Design Review Board Agenda

June 21, 2018

**CITY OF MILL CREEK
DESIGN REVIEW BOARD
APPLICATION PL2018-0005**

NAME OF PROJECT: Canyon Creek Church

Attachment 4 - Landscape Plan

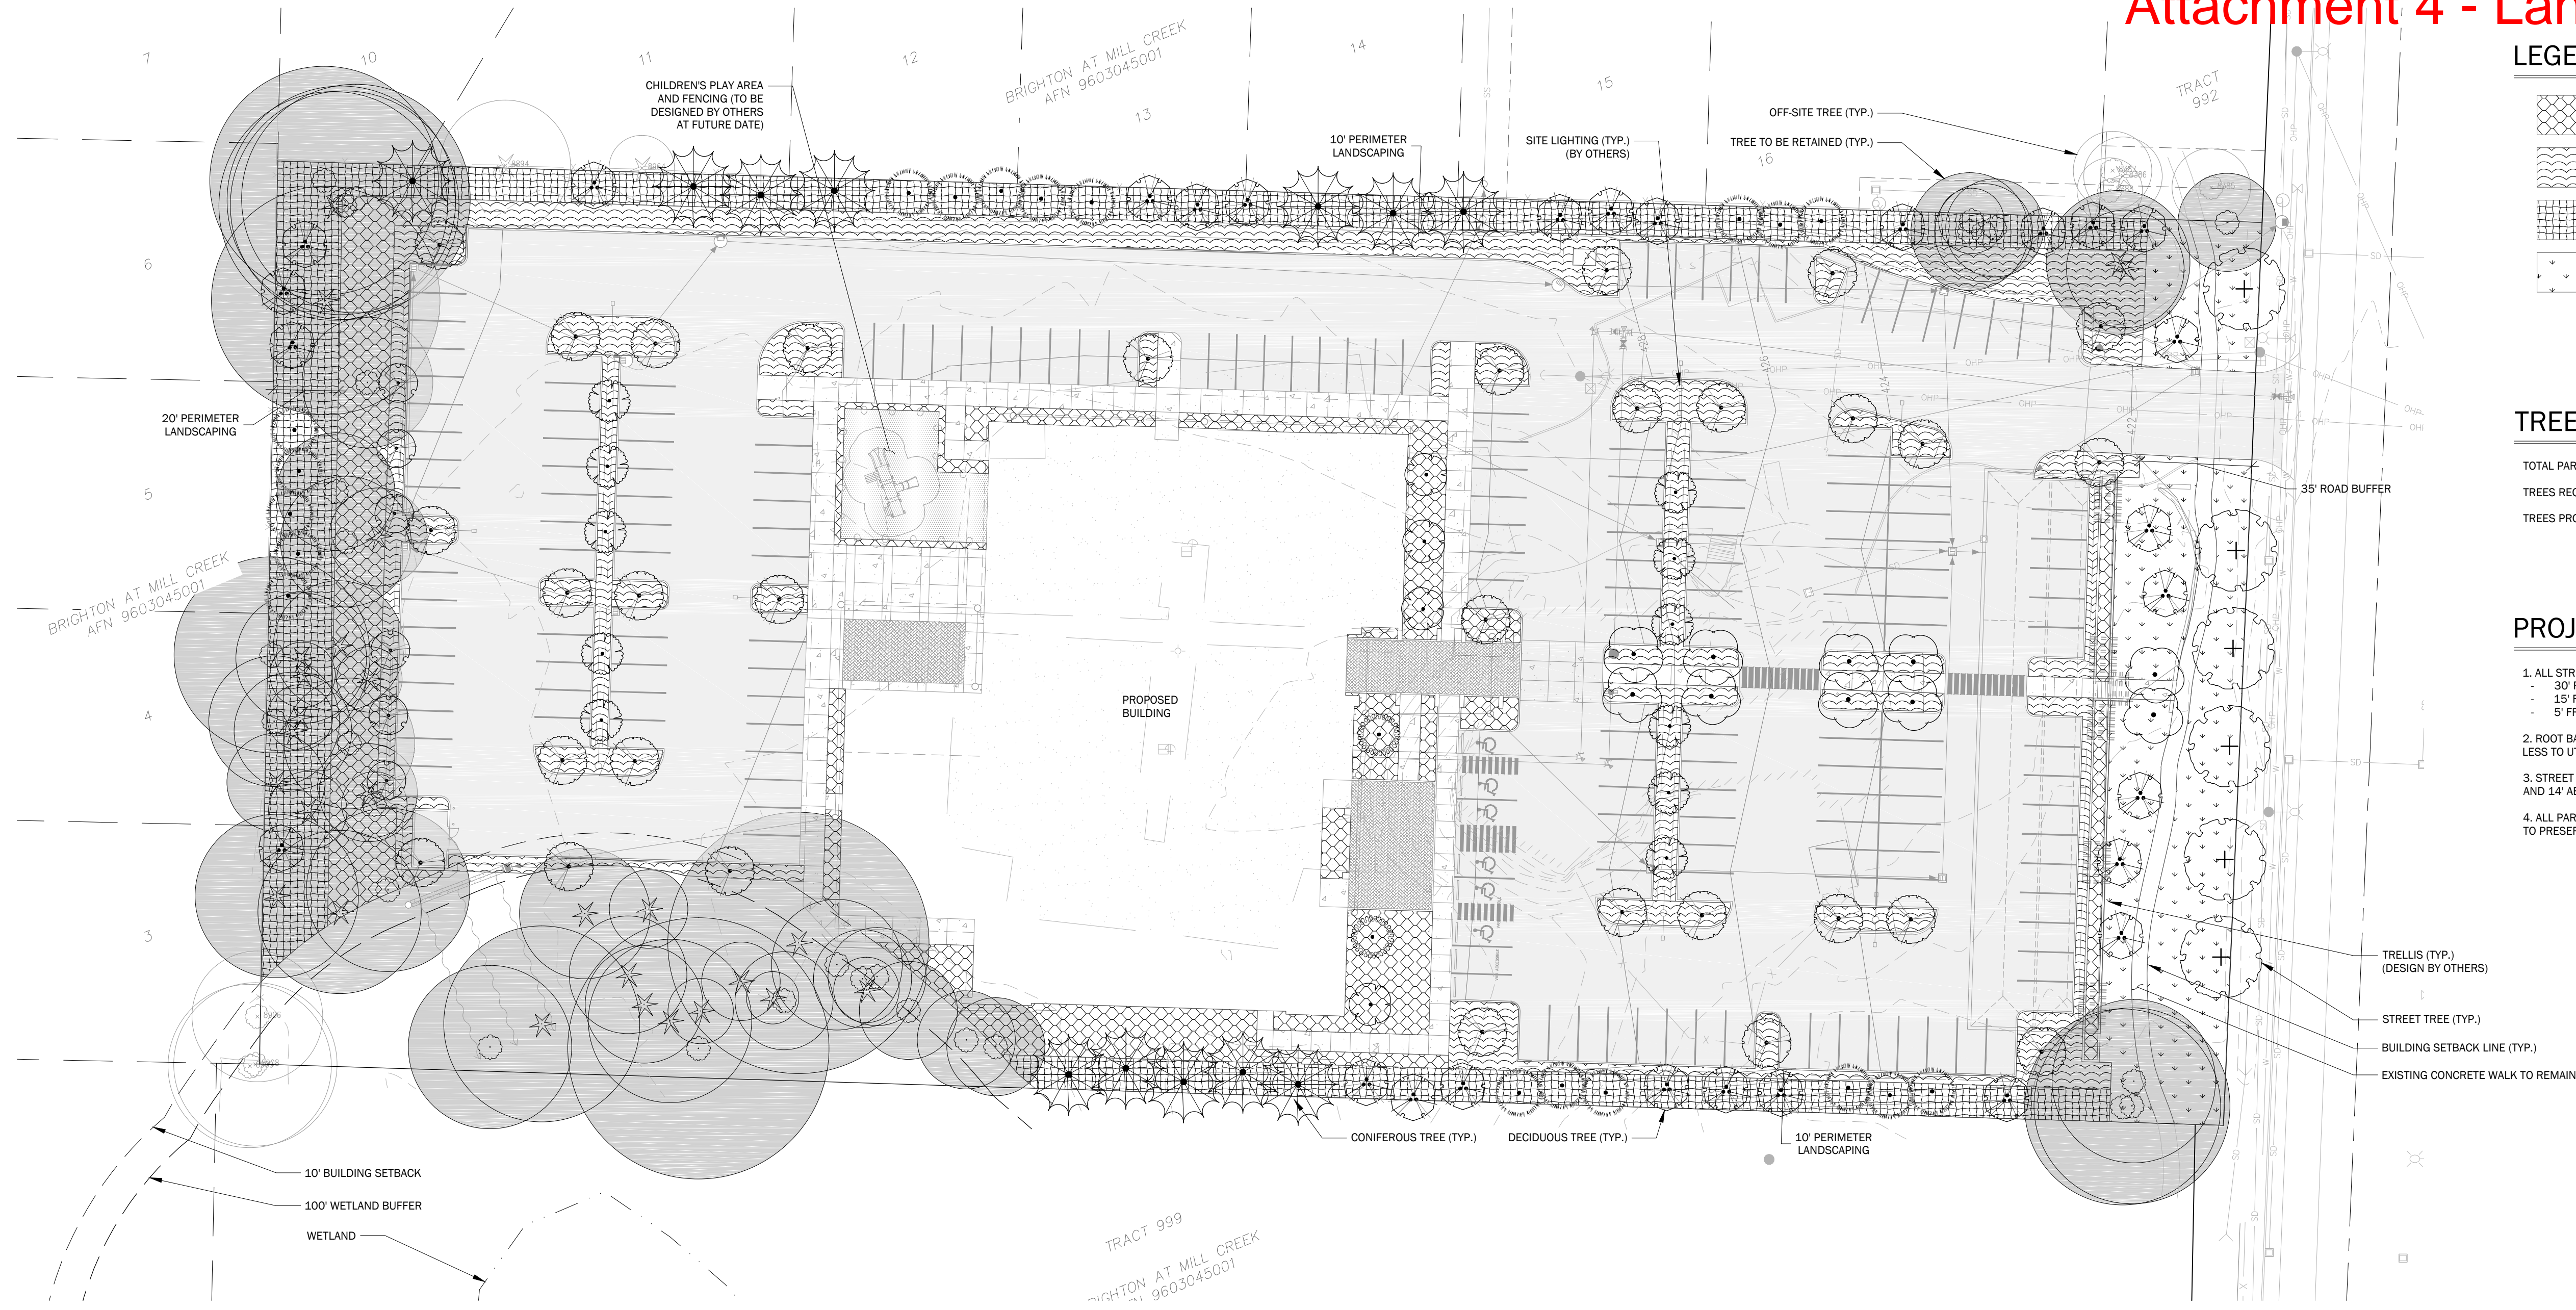
Staff is recommending the following as Conditions of Approval to the Landscape Plan:

- Replace the Western Sword Fern in the parking lot landscaping with another evergreen shrub, as staff has seen in past applications that sword fern is not a successful plant selection for a parking lot.
- Install trees of varying heights with a minimum height of 8 feet to 12 feet in height to provide a natural appearance and increase the visual vegetative screen along the western and northern property lines.

2. Amend the landscape plan as follows:
 - Add Climbing Star Jasmine to the plant legend to be planted on the building trellis's on the western and southern facades.

- Replace the Western Sword Fern in the parking lot landscaping with another evergreen shrub.
 - Install trees of varying heights with a minimum height of 8 feet to 12 feet in height to provide a natural appearance and increase the visual vegetative screen along the western and northern property lines.

- Add the monument sign location on the landscape plan with the five foot property line setback.
3. A landscape performance bond in the amount of 125% of the proposed cost of materials and installation shall be provided to the City prior to beginning construction of the binding site plan, pursuant to MCMC Section 16.16.040.
